**Subject: Mayflower Special Permit Application  
116 Woodbury Road  
Washington, CT 06793  
Airborne Acoustic Analysis**

**Date: February 3, 2022**

**Revision: 2**

Figure 5. Diffraction Estimate at 23 Wykeham Rd for Music Shed with Source Centered in Shed

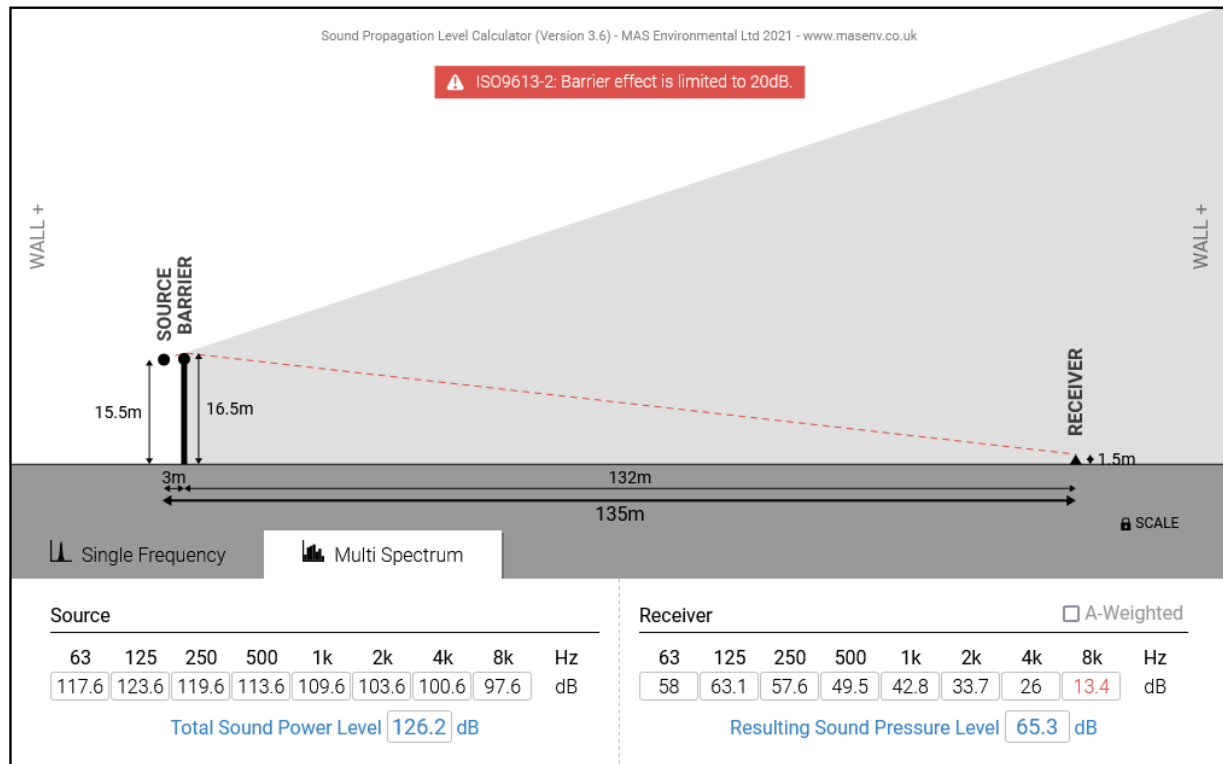
Another very important issue of concern is the music that is diffracted around the edge of the music shed. Assume that we turn off the multiple small format loudspeakers that are in the tent and just look at the sound directly leaving the music shed. Some of that sound will diffract around the west edge of the shed and head towards the nearby neighbors. This diffraction is depicted in Figure 5. We assume the shed is about 20 feet wide and the source is in the center about 1 meter back from the front edge of the shed. Figure 5 shows that the level at the closest neighbor has dropped from 75.4 dBA to 65.3 dBA. If we add another 10 dB for the absorber material on the tent walls the result is about 55 dBA, not the 35 dBA that was predicted in reference 2. If we move the source further back from the edge by a half meter the noise level at 23 Wykeham only drops by 1 dB. If we move the source from the middle to 5 feet from the west edge the noise level at 23 Wykeham again only drops by 1 dB. Because of the diffraction around the west edge, the shed is probably capable of only about a 10 dB improvement over not having a shed. This means that by this mitigation approach only a 20 dB total improvement is possible. The nearest neighbors would see 55 dBA levels, near or just below the daytime CT noise limit.
